ITEM 6. DEVELOPMENT APPLICATION: 13 JOYNTON AVENUE ZETLAND**FILE NO: D/2012/1061****DEVELOPMENT APPLICATION NO: D/2012/1061****SUMMARY**

Proposal Summary: The subject application seeks consent for a Stage 2 development application for the detailed design of 4 residential apartment buildings ranging in height from 5 to 9 storeys, and encompasses the following:

Figure 16: Clerestory window elements of Building A2 in breach of the approved Stage 1 building height

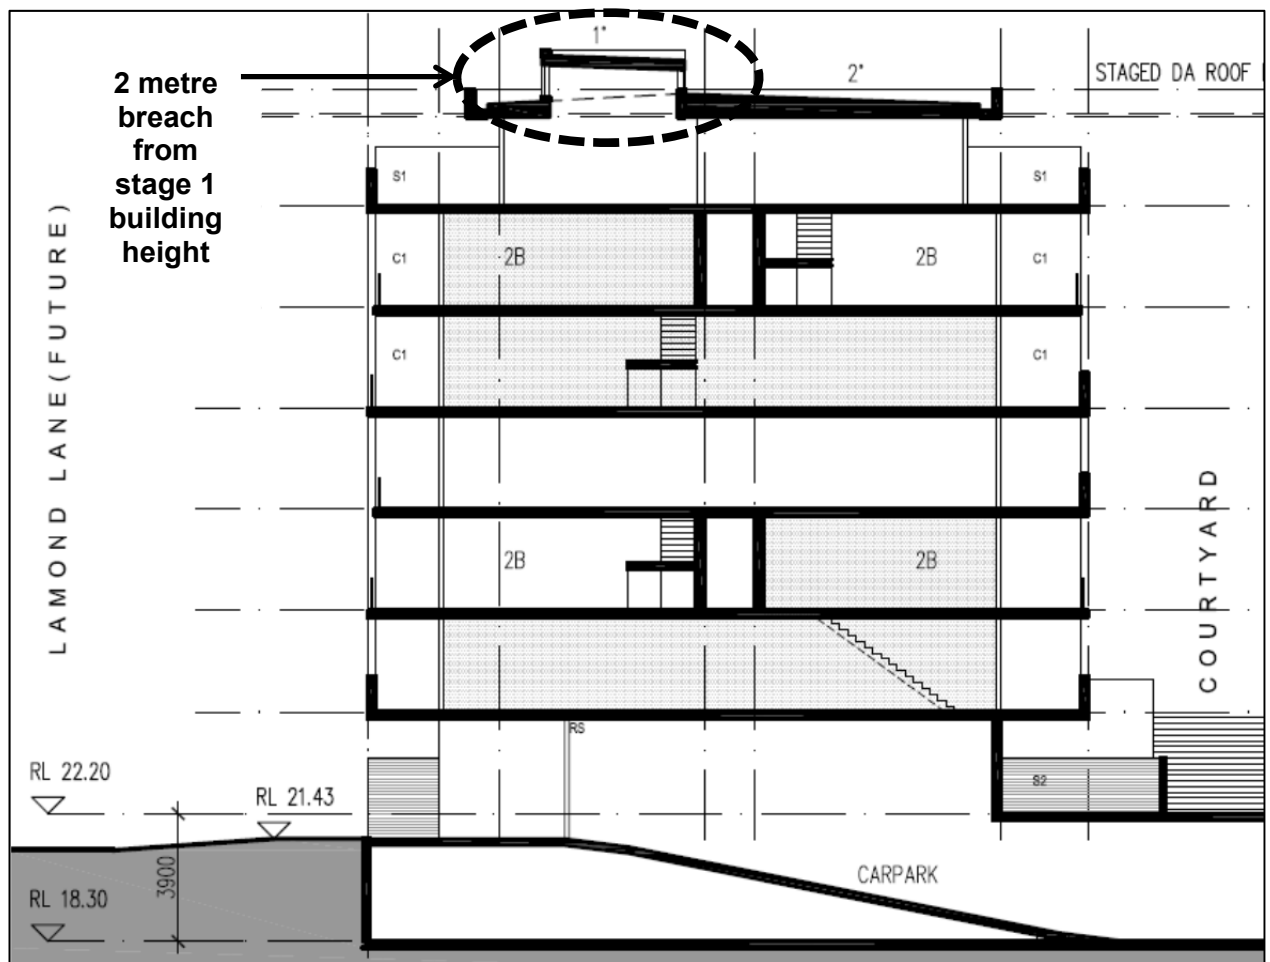
62. The South Sydney DCP 1997 stipulates a 12 metre height control for the entire site, however, the Stage 1 consent superseded this control, and stipulated the following building heights (as measured to the uppermost structure):
 - (a) Building A1- 15.3 metres;
 - (b) Building A2 - 22.47 metres;
 - (c) Building B – 24.65 metres; and

- (d) Building E – 33.7 metres.
- 63. The proposal has reduced the height of Building E by 2.8 metres under the Stage 1 approved building envelope. Minor increases are proposed to Buildings A1, A2 and B as a result of introduction of the shade structures on the roof top terraces in Building B and clerestory windows in Buildings A1 and A2. The location and extent of breaches in height are detailed in Figures 16 and 17, below.
- 64. In this instance, the increases in height are considered to be minor (being between 600mm and 2 metres), and have been appropriately setback from all elevations of each building to reduce visibility, perceived additional bulk and creation of additional amenity or environmental impacts. As such, no objection is raised as the overall envelope is consistent with the approved building envelope and intended scale.

Figure 19: Location of the proposed window projections and reduced separation between Buildings B and E

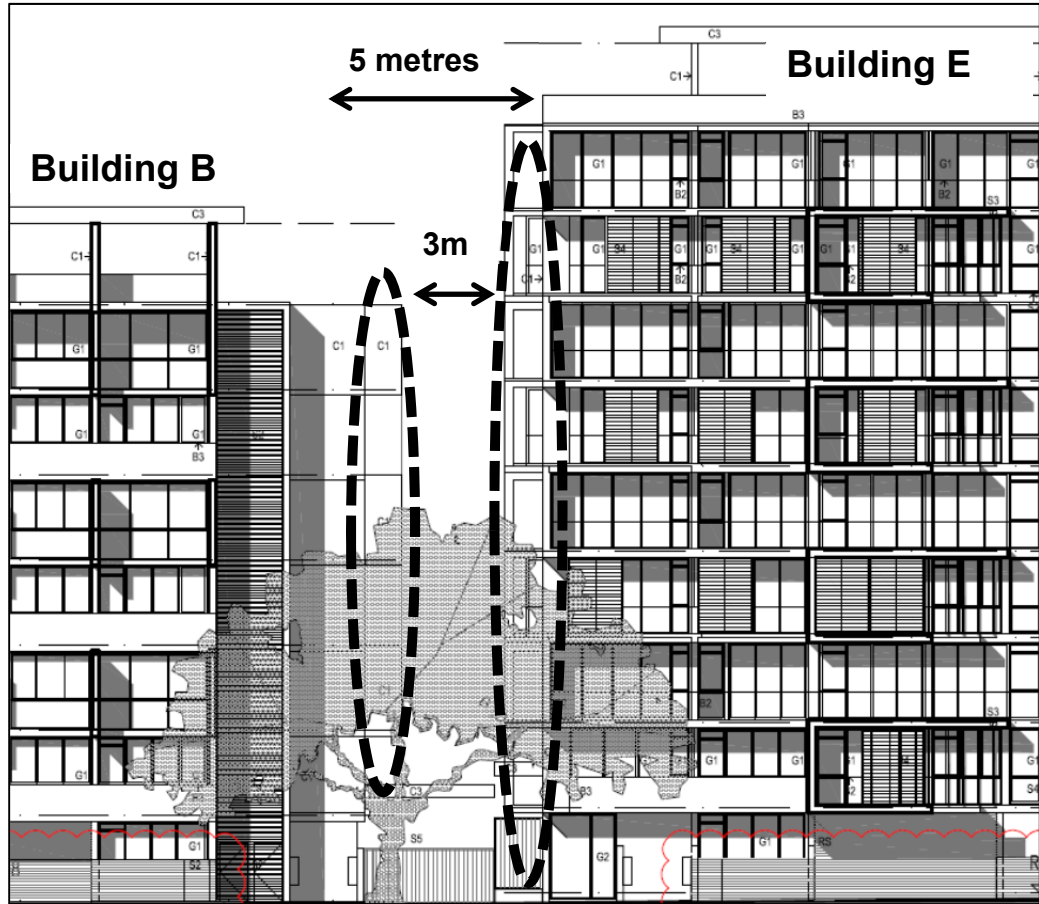
- (b) the addition of the window projections provide articulation and visual interest to what was previously blank unmodulated facades (refer to photomontage at Figure 18, above);

- (c) the introduction of these window projections provide increased visual and acoustic privacy to the occupants of these apartments; and
 - (d) all windows and associated window projections are offset, and do not allow any overlooking between units.

Figure 22: The proposed retail tenancy in Building A2 (circled) as viewed from Lamond Lane and Mary O’Brien Reserve

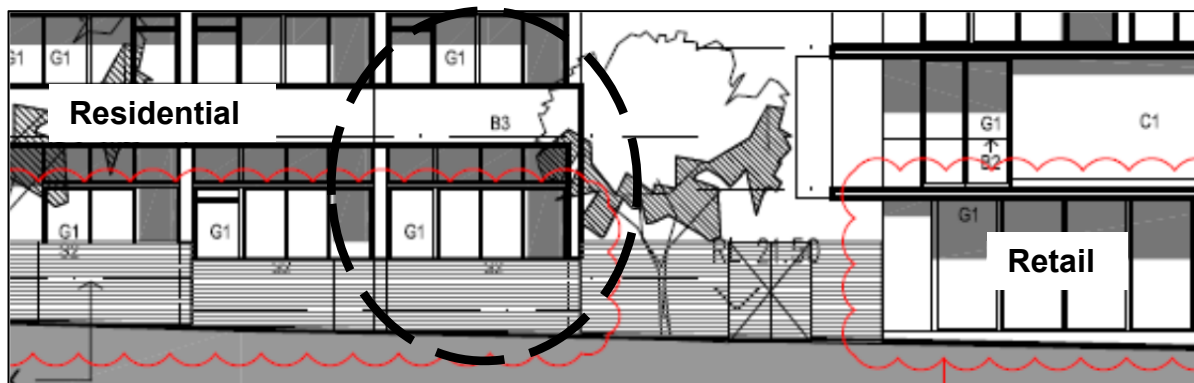
84. The amended scheme has introduced a new retail tenancy on the ground and first floor levels of the southeastern corner of Building A2. Whilst this is considered to be a positive addition to the development to cater to both future residents of the development and the broader local community, it is considered that the architectural language and streetscape treatment of this retail tenancy appears residential in context (refer to **Figure 22**, below).

85. It is considered that there are opportunities to alter the facade treatment of this retail tenancy to make it more accessible and open to the street and distinguish it from adjacent residential apartments. A condition of consent is recommended that amended plans be submitted modifying the southern facade treatment at both ground and first floor level of this tenancy.

- (a) Amended plans shall be submitted to modify the design and external appearance of the retail tenancy located on the ground and first floors of the southeastern corner of Building A2. The modified scheme must consider the following matters:
 - (i) A reduction in the height of the front fence of the tenancy and/or use of a more translucent material to improve visibility to the tenancy from Lamond Lane;
 - (ii) Deletion of the first floor level southern elevation balcony; and
 - (iii) Modified facade treatment of the southern elevation at both ground and first floor level to distinguish this tenancy as a retail/commercial unit.
